Subject ➤ Addition of Line filter, Change of Brush holder

For Models ➤ BUC250, BUC250C, UC250CD, UC250D, AS3625, AS3625C, AS3626, AS3626C

Fig. 1

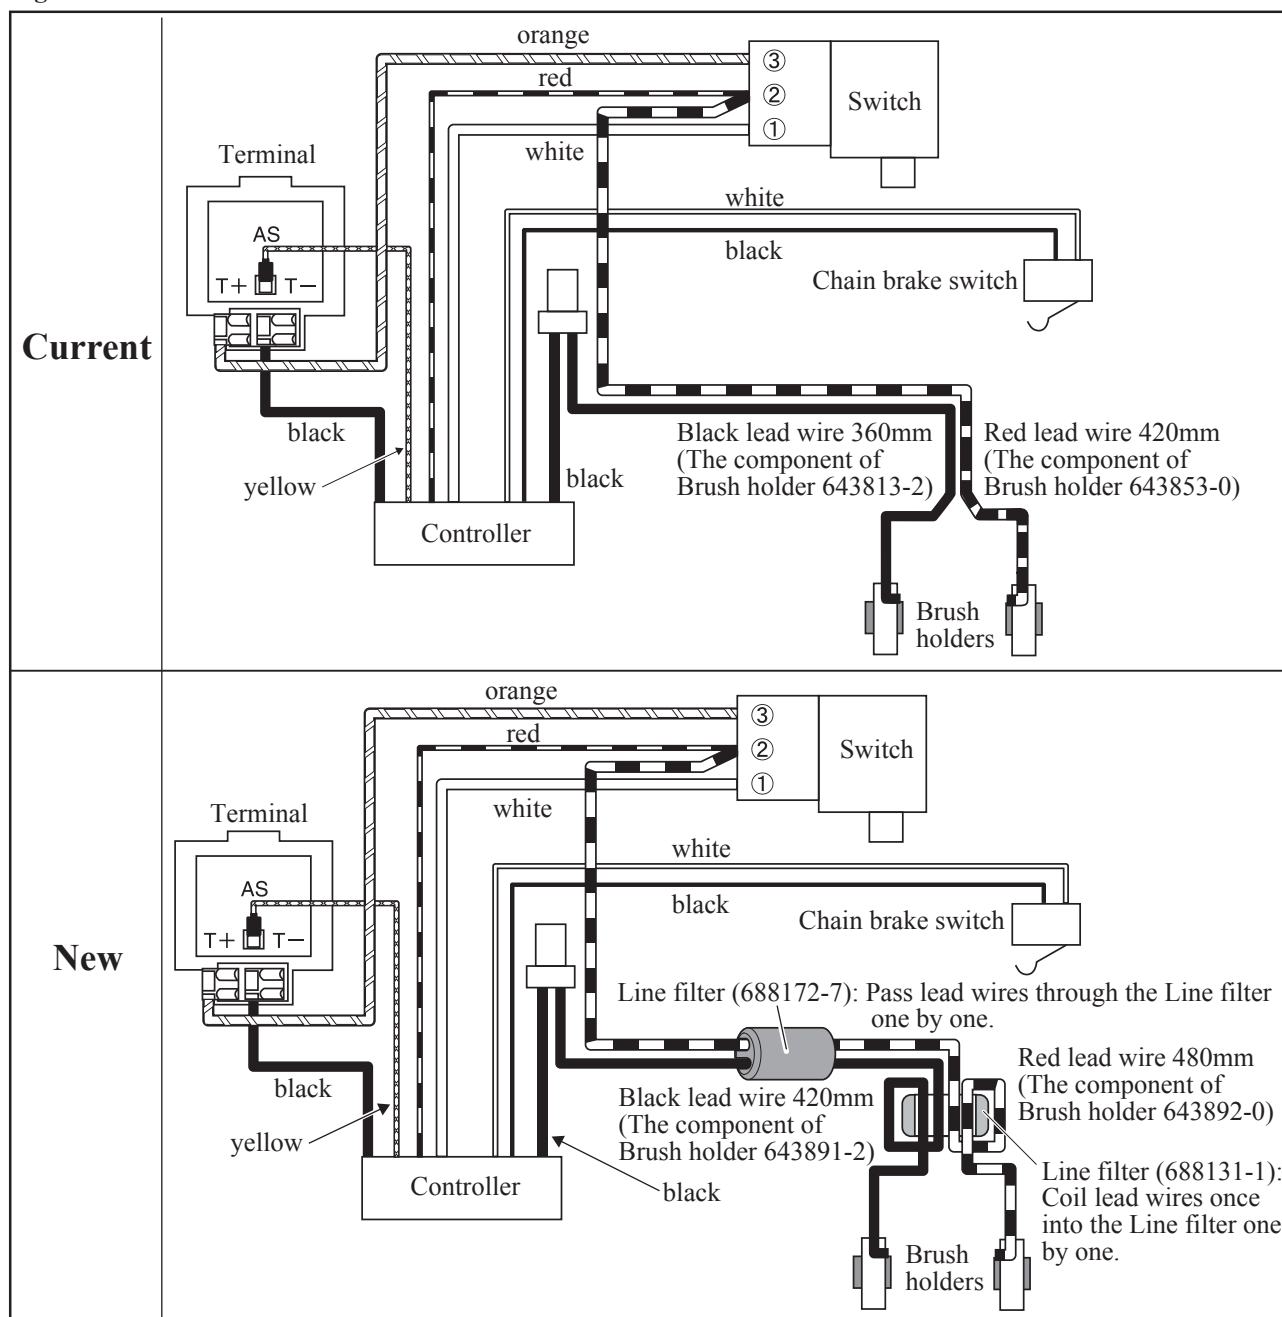
Description ➤ To comply with EMC for DC tools;
 • Line filters have been added.
 • Brush holders have been changed.
 See below and next pages.

Item No.	Current part		Q'ty	I/C	New part		Q'ty	Note
①	See below.	-----				Line filter 688131-1		1	See Figs. 1 and 2.
②	See below.	-----				Line filter 688172-7		1	See Figs. 1, 2 and 3.
	007	Brush holder 643853-0		1	No	Brush holder 643892-0		1	See Figs. 1 and 2.
	006	Brush holder 643813-2		1	No	Brush holder 643891-2		1	See Figs. 1 and 2.
